Axis J9 Phase 3

Technical Note - Response to OCC Highways Consultation Response 22/2/22 Application No. 21/03177/F

Drawing Title. PROPOSED SITE PLAN

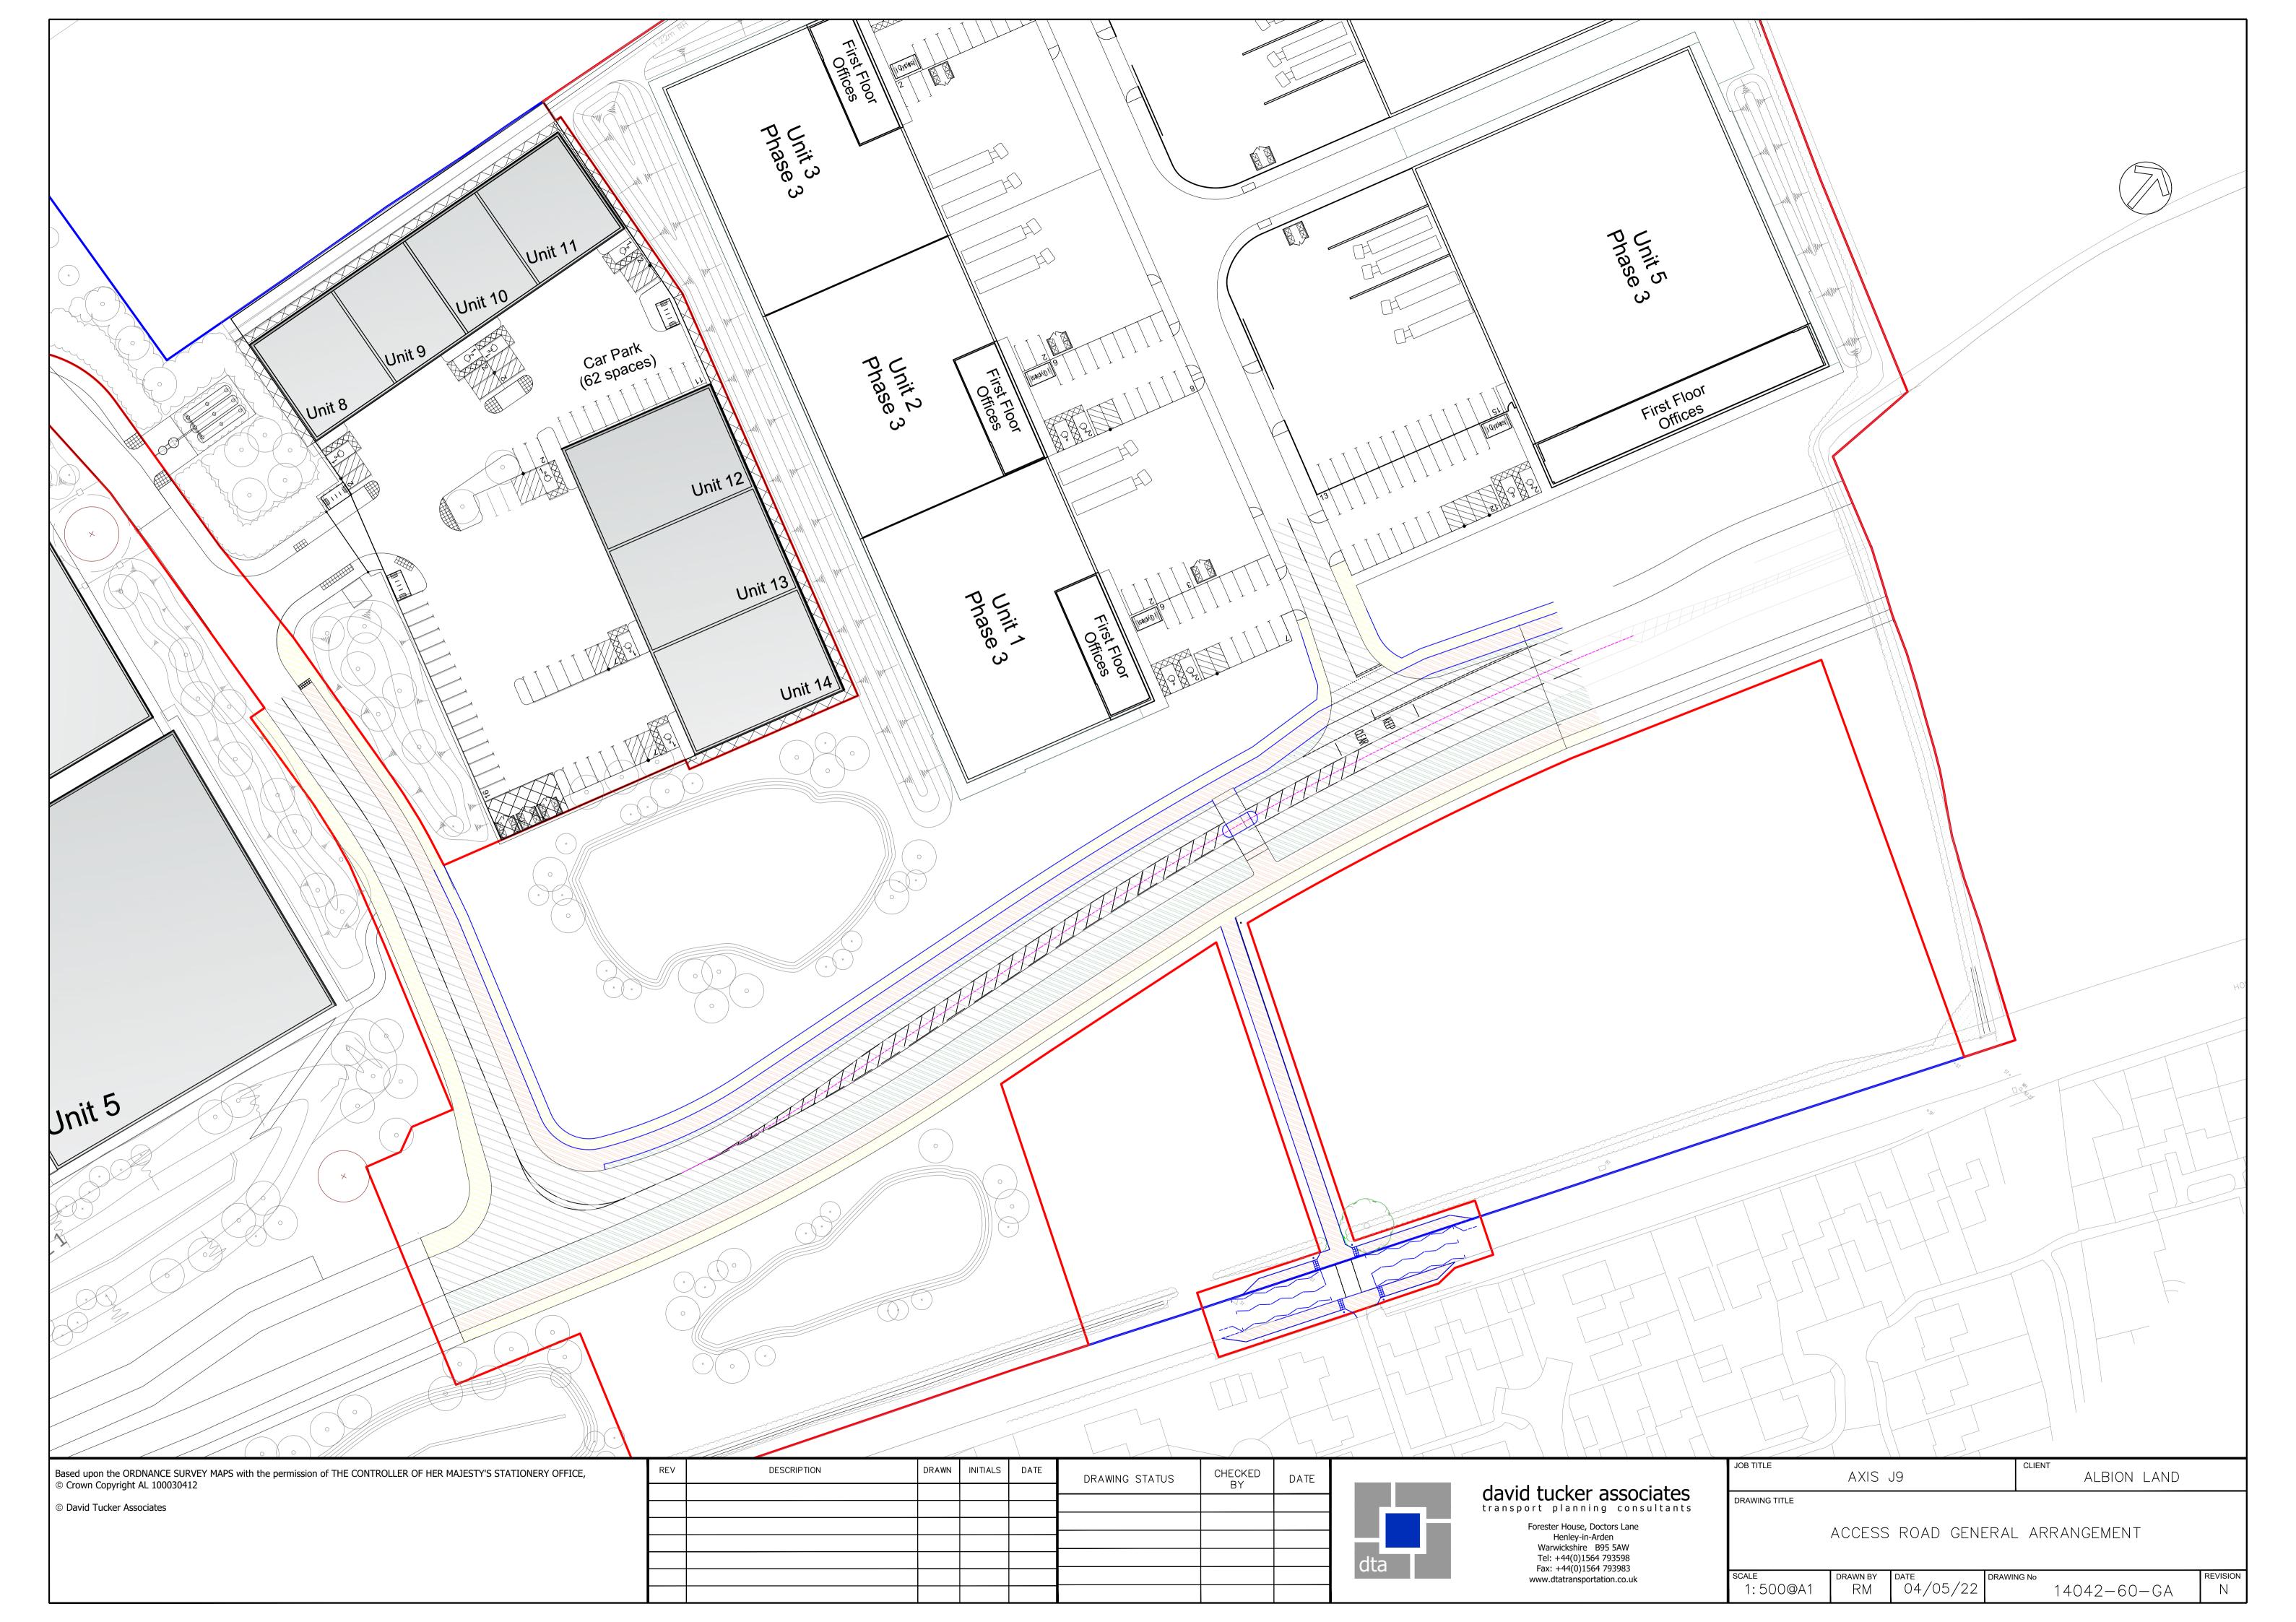
- 5. In terms of cycle parking for Units 1, 2 and 3, this has been swapped with car parking as suggested by OCC. This is illustrated on re-submitted Cornish Architects Proposed Site Plan No. 20019-TP-002 Revision R (included as **Appendix A**).
- 6. It is considered that the above fully addresses the OCC detailed comments.

R Width of cycle lane to west side of SLR increased to 3m, grass verge to west side of SLR, width of link to Howes Lane increased to 3m,Units 1 - 3 cycle parking relocated
